ADDENDUM NO. 02

Project: Conway Corporation
Roger Q Mills Jr.
Water Treatment Plant 8 MGD Expansion & Improvements

The Contract Documents dated May 3, 2024, are hereby amended as follows:

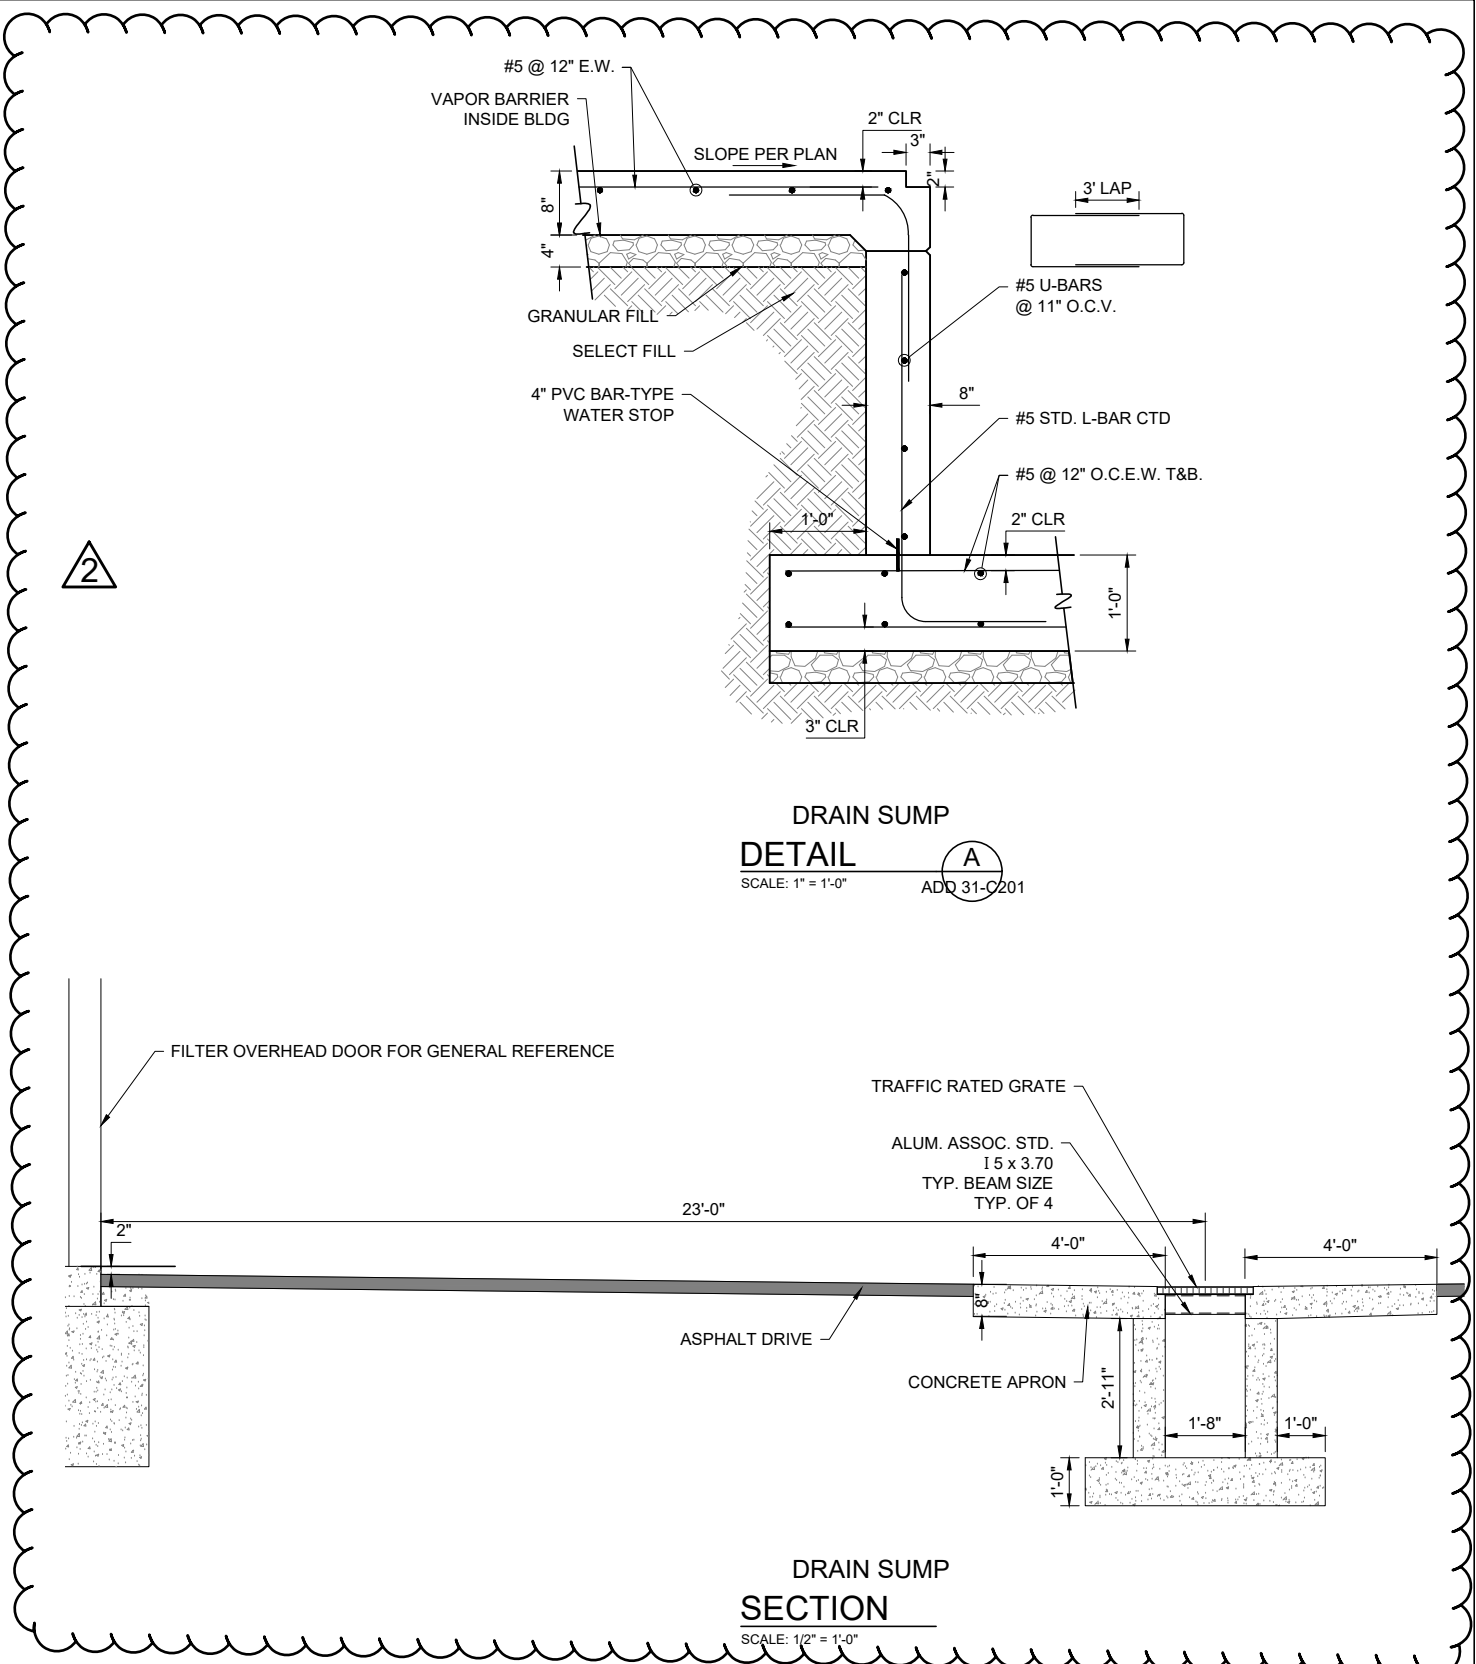
20. Drawing No. 31-C201 (Sheet No. 151)

- a. Modify the Drain Sump Pump Section shown on Filter Building 2 Drive Drain Plan and Profile – Addendum No. 02, attached hereto.

CEI JOB NO.: 2135
GARVER JOB NO.: 19W01300
DRAWING NUMBER 31-S304
SHEET NUMBER 163

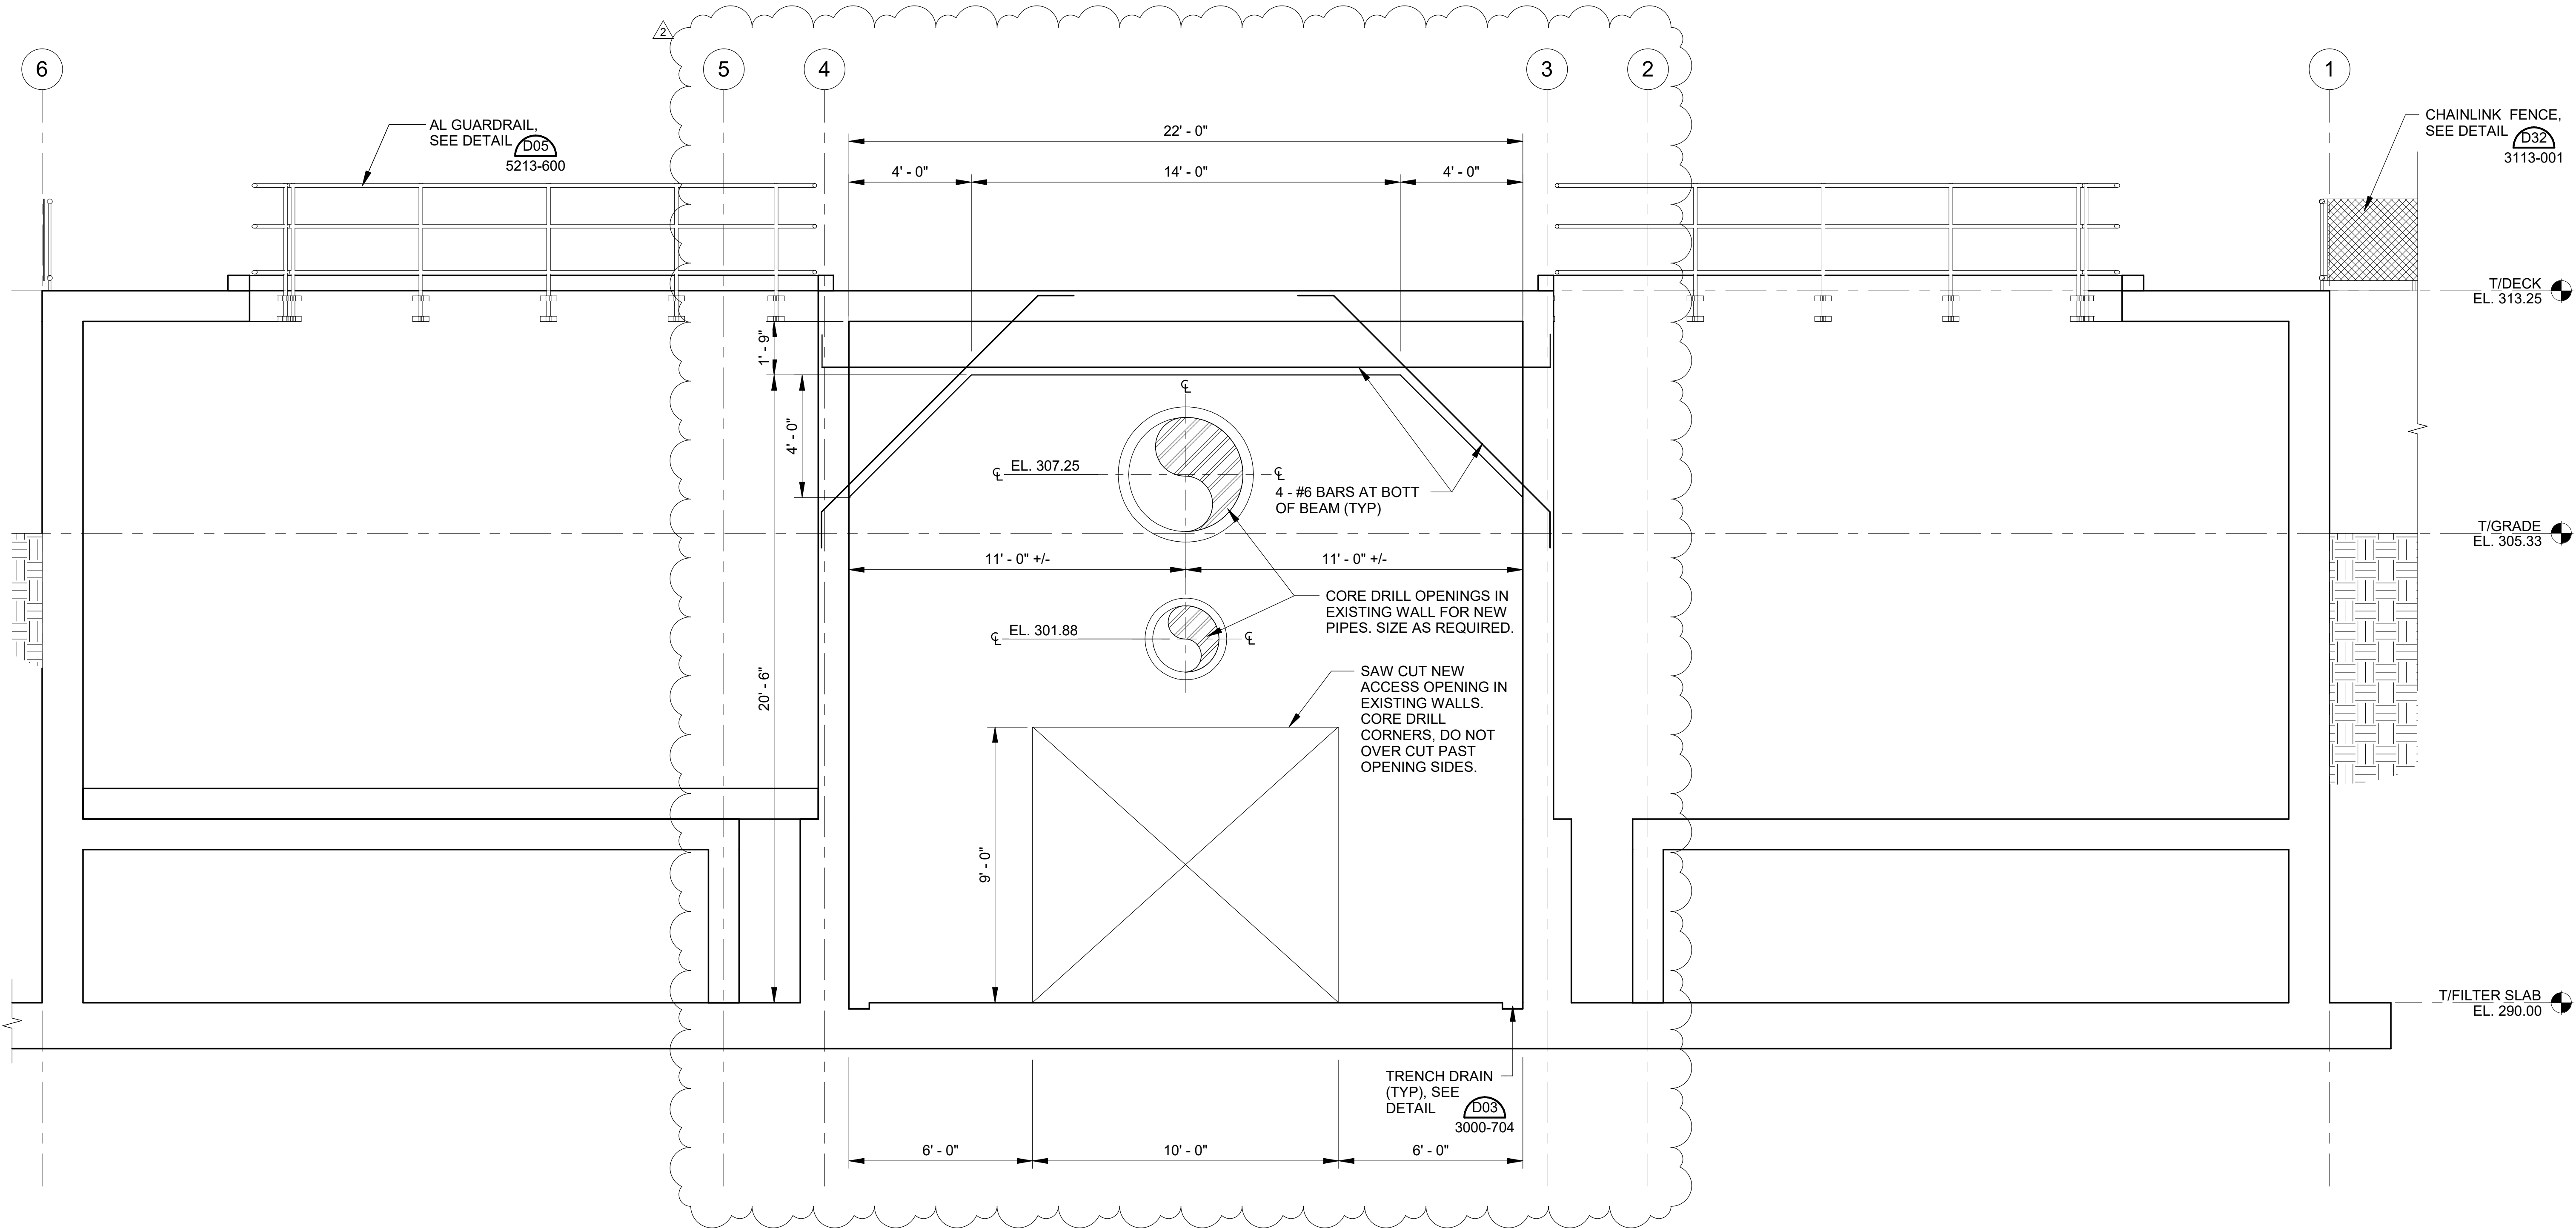
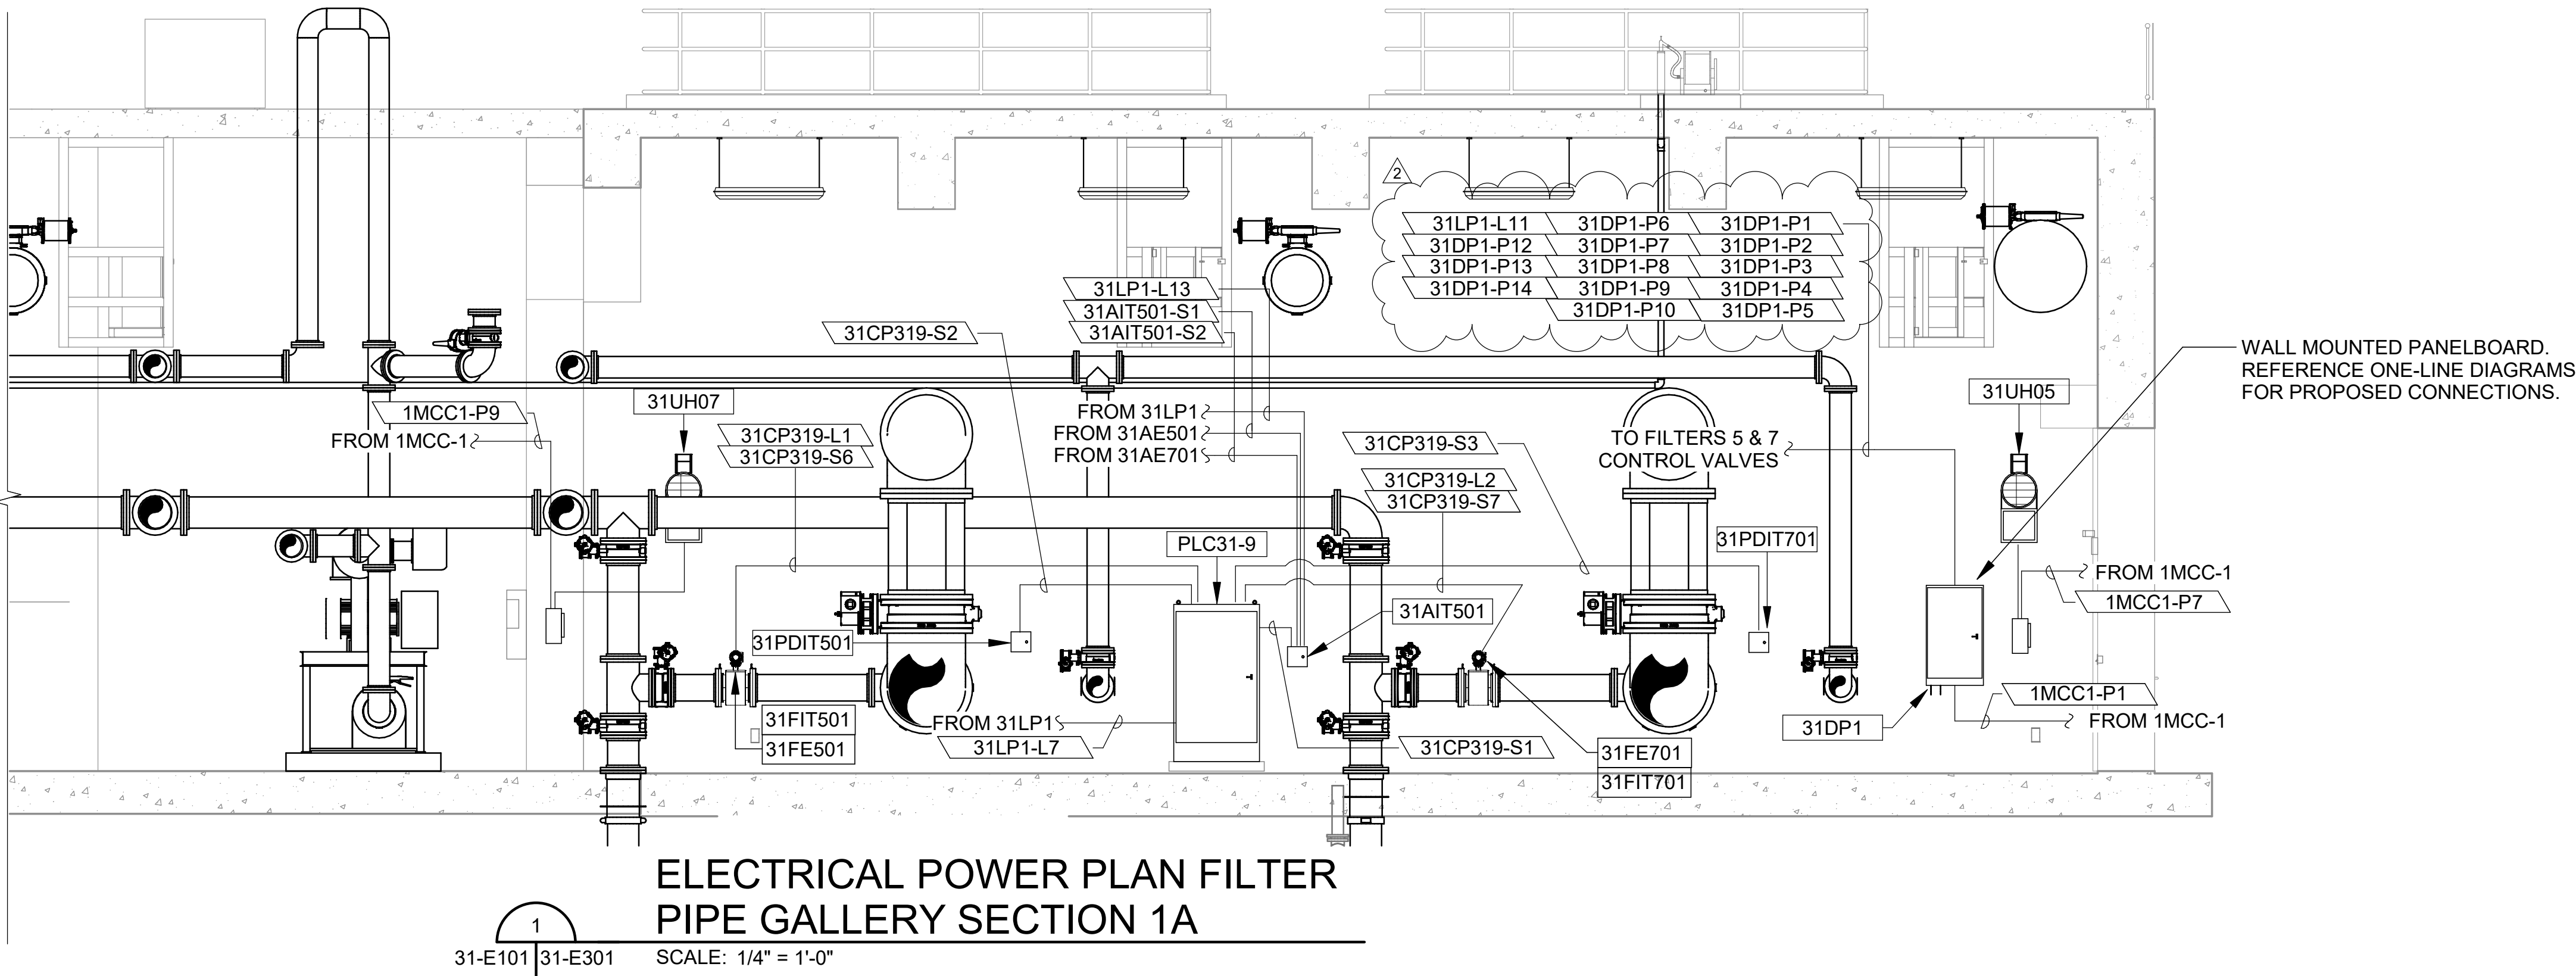
21. Drawing No. 31-S304 (Sheet No. 163)

- a. Delete the entire drawing and replace it with Drawing No. 31-S304 - NEW PLANT FILTER BUILDING #2 SECTIONS 4 - Addendum No. 02, attached hereto.

CEI JOB NO.: 2135
GARVER JOB NO.: 19W01300
DRAWING NUMBER
31-E301
SHEET NUMBER **186**

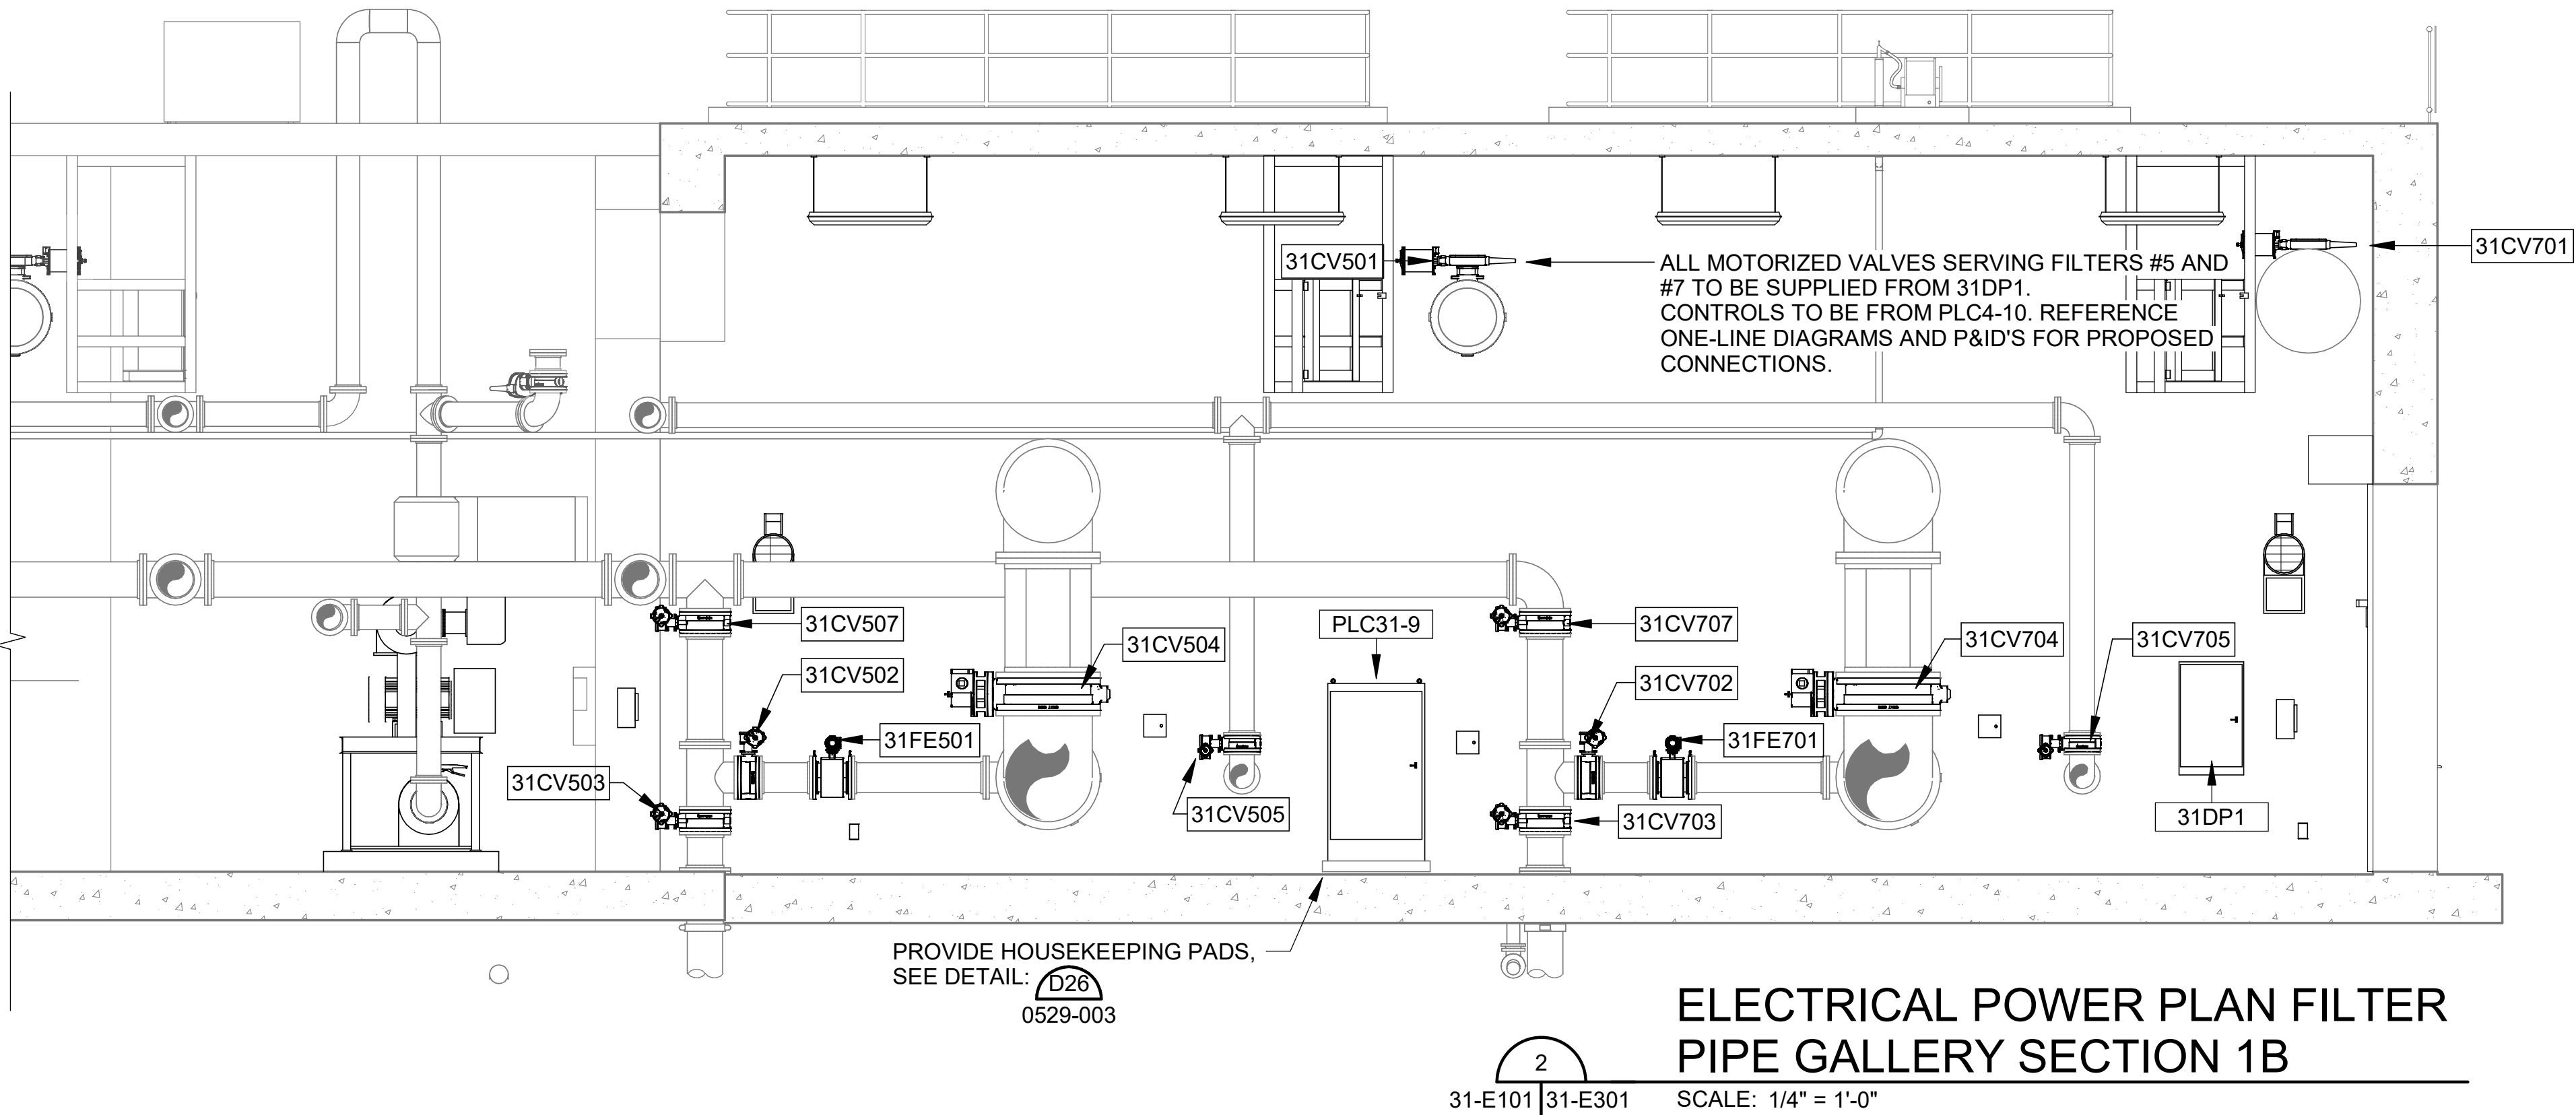
22. Drawing No. 31-E301 (Sheet No. 186)

- a. Delete the entire drawing and replace it with Drawing No. 31-E301 - NEW PLANT FILTER BUILDING #2 ELECTRICAL POWER PLAN SECTION 1, - Addendum No. 02, attached hereto.
